PARTS BULLETIN

Models: 8-22 kW with Ford VSG-413 Engine

Subject: Ignition Coil and Spark Plug Wires

Figure 1 Ford VSG-413 Ignition Coil and Spark Plug Wires

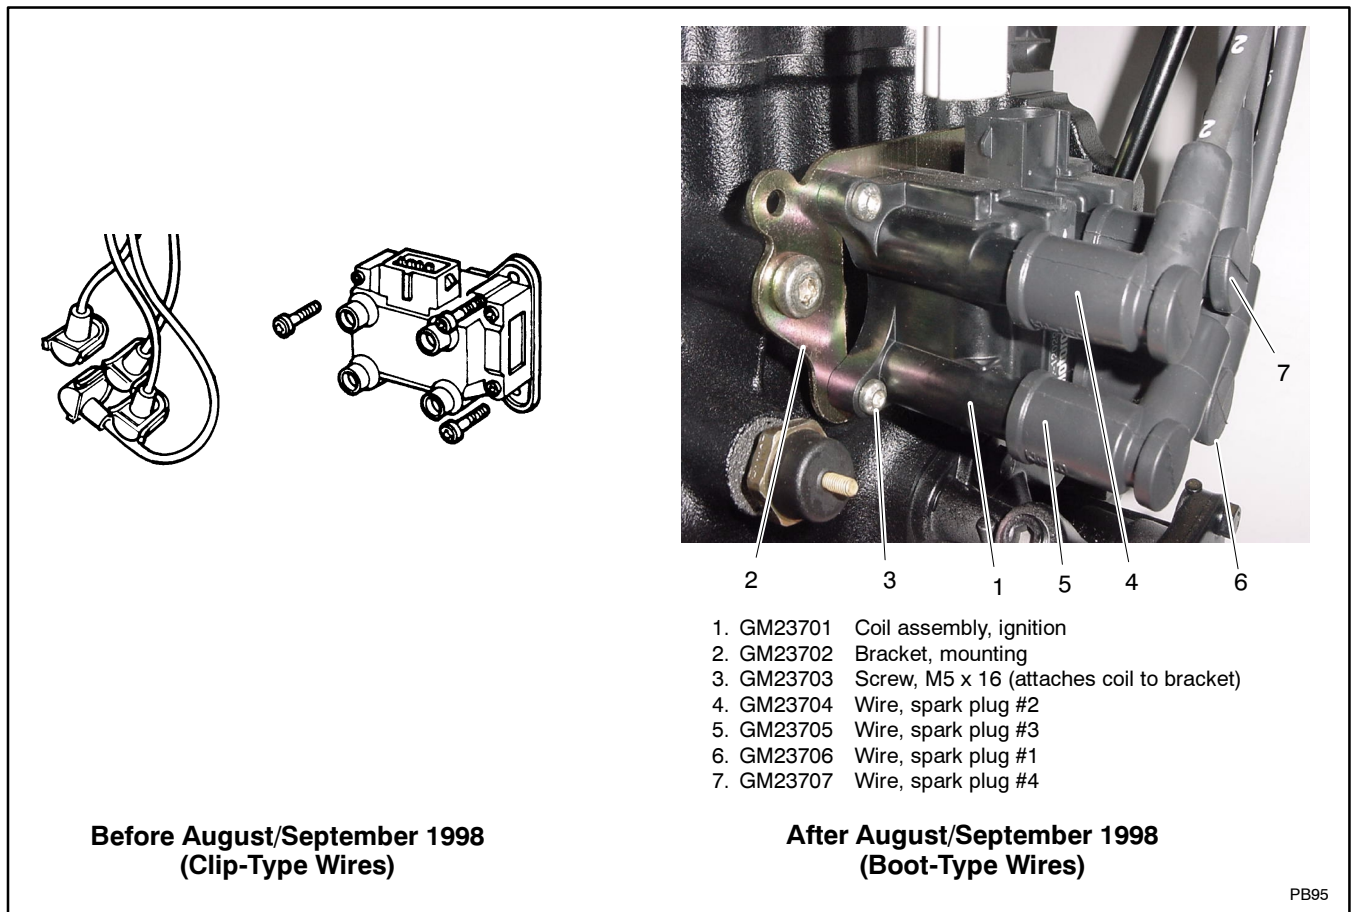
Ford Power Products installed a new ignition coil and spark plug wires on VSG-413 engines to improve ignition coil performance and durability. The change took place with approximately August/September 1998 engine production.

When replacing the ignition coil and spark plug wires, **use the Build Date on the engine's nameplate** and the illustrations below to determine if this bulletin is applicable to your unit. For units with build date later than August/September 1998, refer to Figure 1 to

identify replacement parts. Refer to the generator set parts catalog for part numbers if your unit's engine was built before August/September 1998.
